<b>Docket Number:</b>	12-AFC-02C
<b>Project Title:</b>	Huntington Beach Energy Project - Compliance
<b>TN #:</b>	235533
<b>Document Title:</b>	Applicant Petition For Modification of VIS-1 and Approval of a Mural-Based Architectural Treatment
<b>Description:</b>	Huntington Beach Energy Project (12-AFC-02C) Petition for Modification of VIS-1 and Approval of a Mural-Based Architectural Treatment
<b>Filer:</b>	Eric Janssen
<b>Organization:</b>	Ellison Schneider Harris & Donlan LLP
<b>Submitter Role:</b>	Applicant Representative
<b>Submission Date:</b>	11/6/2020 3:57:00 PM
<b>Docketed Date:</b>	11/6/2020

**RE: Huntington Beach Energy Project (12-AFC-02C): Petition for Modification of VIS-1 and Approval of a Mural-Based Architectural Treatment**

**Petition for Modification of  
VIS-1 and Approval of a  
Mural-Based Architectural Treatment**

Attachment B-2. AES HBEP KOP-4 Mural View with HBGS  
Huntington Beach, California  
Source: SPMDesign

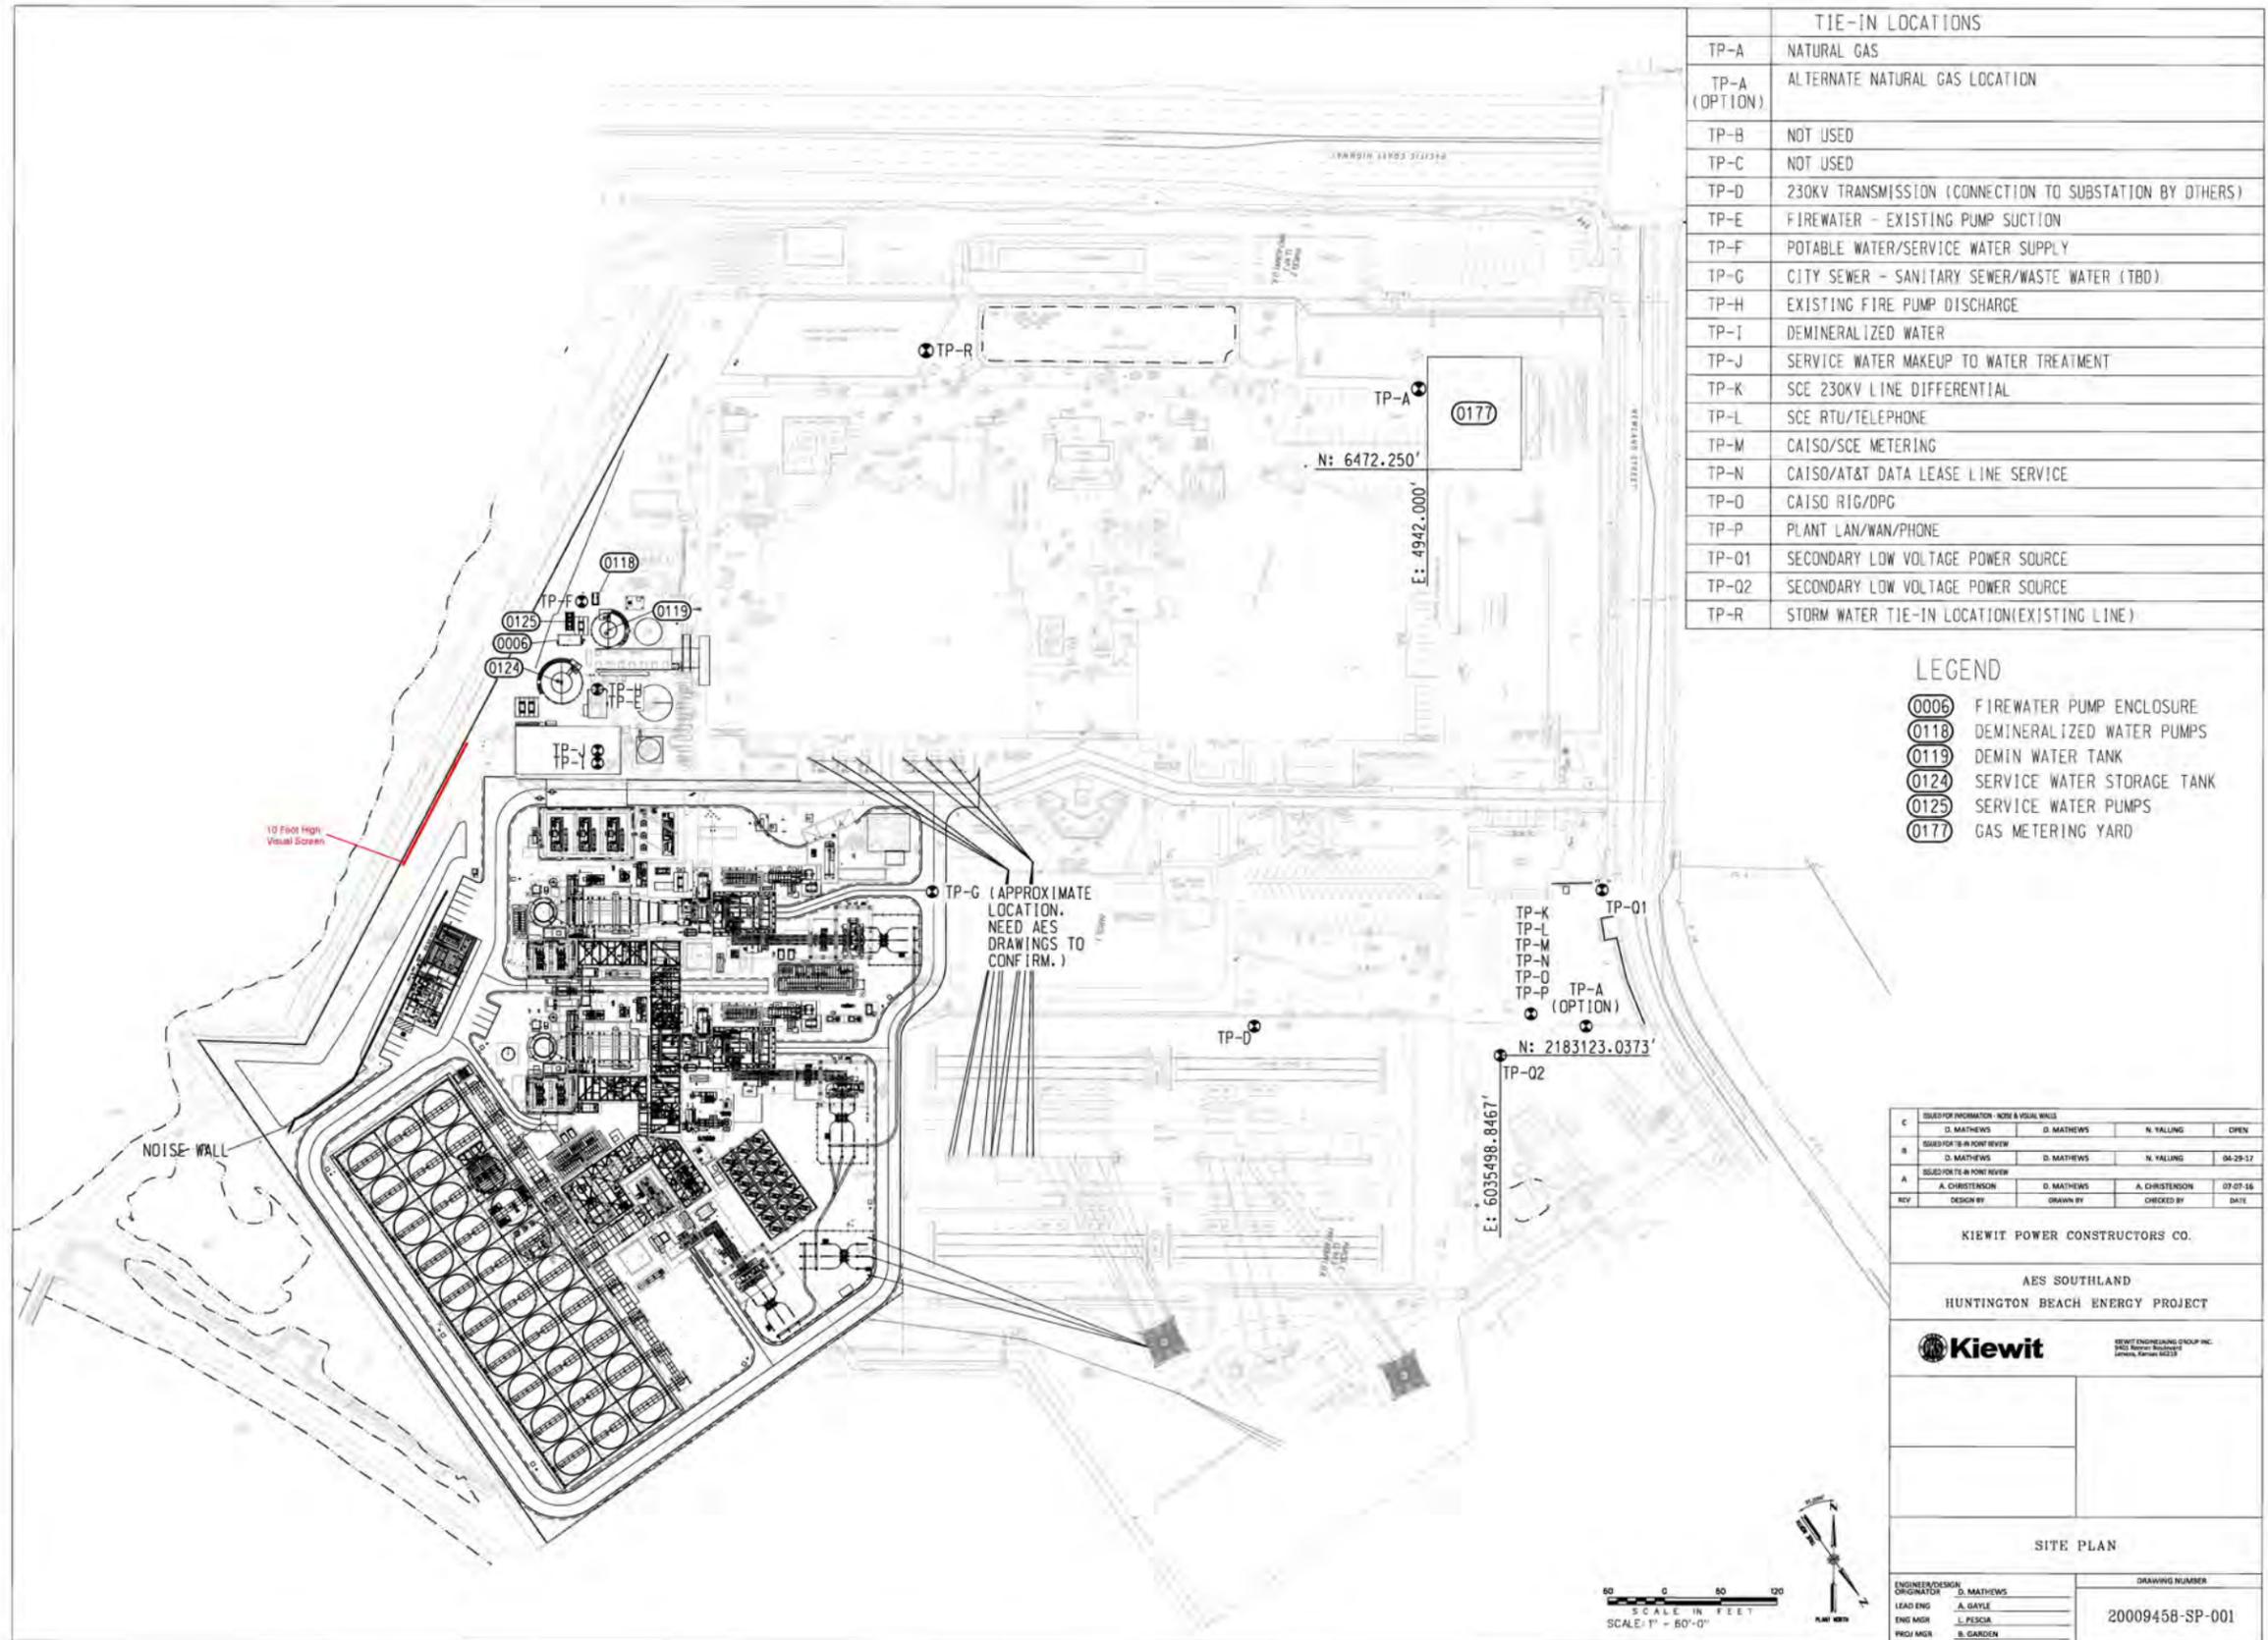
The mural-based architectural treatment was conceived as a replacement to the currently proposed screen or “wave wall” following an extensive public outreach effort to the local community, including several community town hall meetings and surveys, detailed here and in Section VI below. Through this outreach effort, the community supported the development of an alternative to the previously approved architectural screen that was designed as a visual treatment for the HBEP. On November 2, 2020, the City of Huntington Beach adopted Resolution No. 2020-81 supporting a mural-based architectural treatment for the HBEP. Resolution No. 2020-81 includes a City request to incorporate a 10-foot tall visual screen into the mural-based architectural treatment between the sound wall and the water treatment building to eliminate views of equipment at the base of the heat recovery steam generator exhaust stack. AES proposes to erect a 10-foot tall visual screen (approximately 150 feet long) that will be part of the mural-based architectural treatment. This screen will bridge the area between the water treatment building and the sound wall. The revised architectural treatment design is a mural-based surface treatment by a renowned Southern California artist, Kim West. The Kim West Concept is presented in Attachment B to this Petition.

Huntington Beach experience. The mural will span four of the power plant structures: the plant water treatment building, the gas compressor building, the noise attenuation barrier or wall, and the air-cooled condenser (ACC). All of these structures have already been permitted and constructed as approved in the CEC's certification of the HBEP. The mural-based architectural treatment addresses views of the Project from Key Observation Point 4 (KOP-4), incorporates and features the natural environment of the region better than the original architectural treatment, and avoids a number of the potential issues that were identified with the original treatment during the detailed design process. Simulations of the mural-based architectural treatment with and without the Huntington Beach Generating Station units are provided in Attachment |B. Also included in Attachment B is a base photo showing the current view of the HBEP and a revised site plan showing the location of the City requested 10-foot tall visual screen.
